Re: Submission
Re: Amended DA No.:N0276/15 for 168A Barrenjoey Road, Newport 2106

I hereby make a submission related to the amended DA N0276/15 for 168A Barrenjoey Road, Newport 2106.

Part Drawing and Specifications of the East Retaining Wall

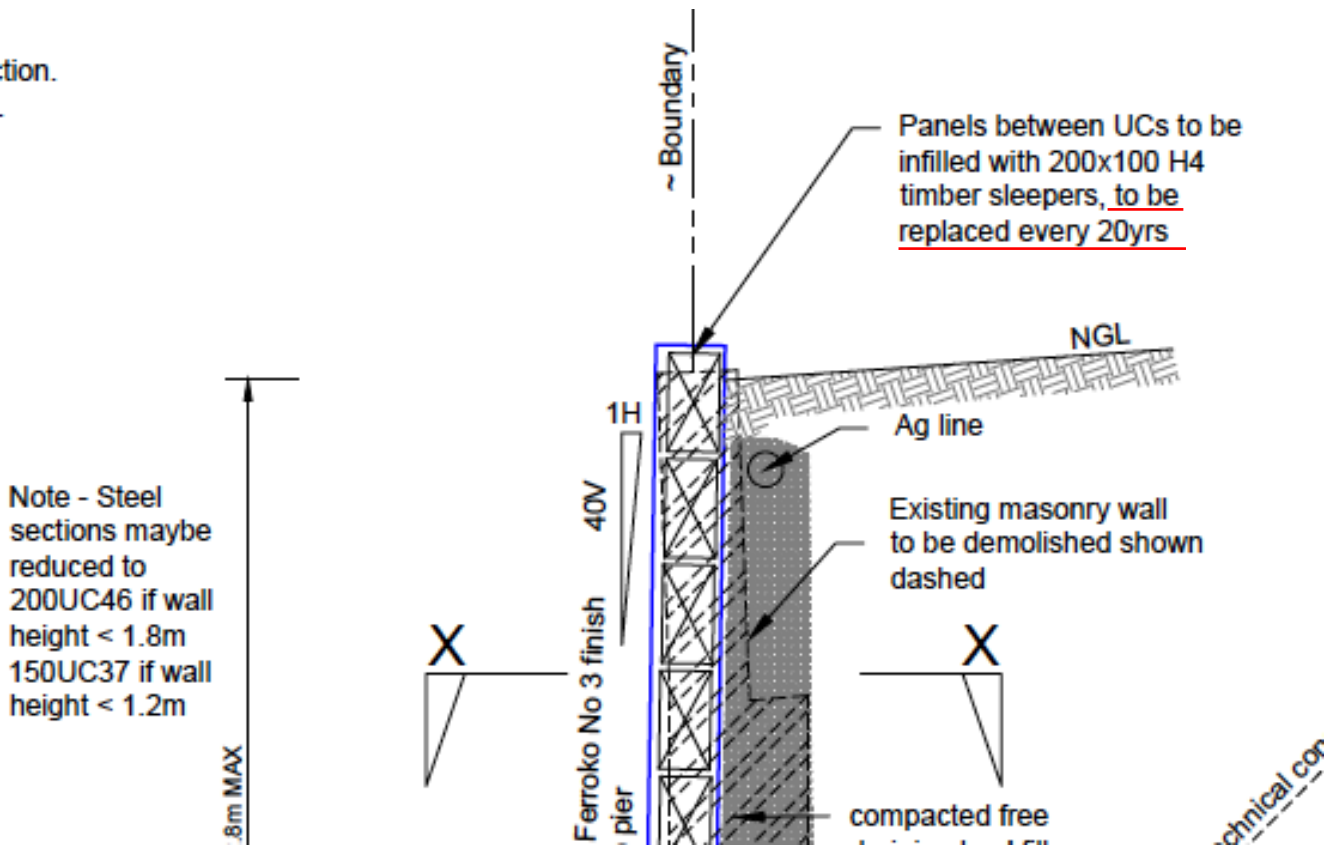
Whilst the new retaining structure is designed in consideration of the H1 hazard classification in the structural design, in consultation with Geotechnical engineers, it is based on the requirement of 10-year inspection and full-length replacement of the timber sleepers retaining the soil, at maximum 20-year period. Please find attached document Document A1- *Structural Eng. Design Criteria 20Yr replacement*, showing part drawing and specification for your review.

This means that not only the access is required to remove and replace the timber sleepers, but also upon removal of the timber sleepers, the retained soil will fall out and will need to be replaced subsequent to replacement of the timber sleepers.

I request your note that there is a 10 year inspection regime specified by the Structural Eng. Hence, there is a possibility that the timber sleeper may require replacement in 10 years or may require additional bracing/ anchoring etc., depending on the nature of the problem.

DESIGN LIFE OF THE STRUCTURE

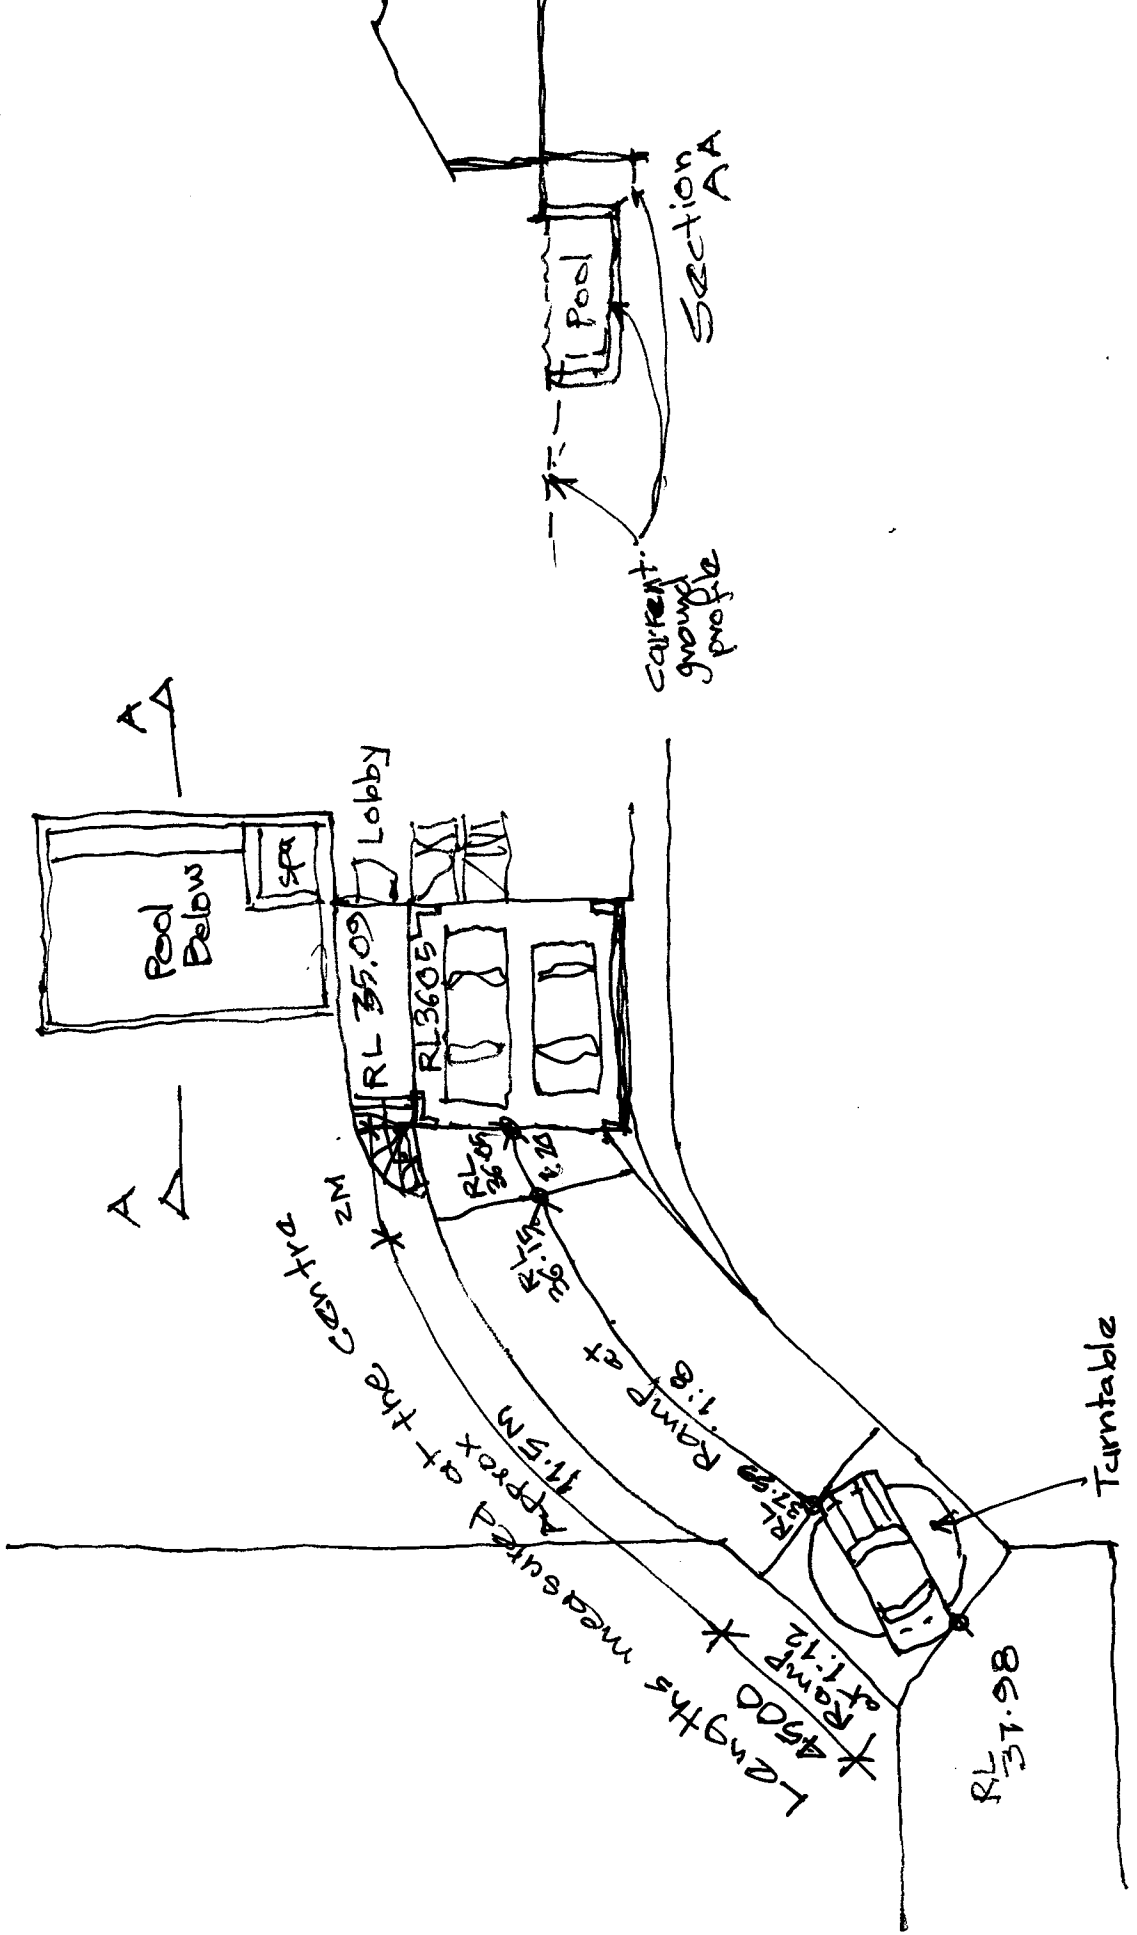
In addition to the aforementioned contravention A1a) and B1a.4), the in-ground swimming pool requires excavation in excess of 45 CuM. This can be minimised by locating the pool adjacent to the house where the current land profile will require much less excavation and cut and fill.

- The swimming pool should be located in front of, adjacent to the house;
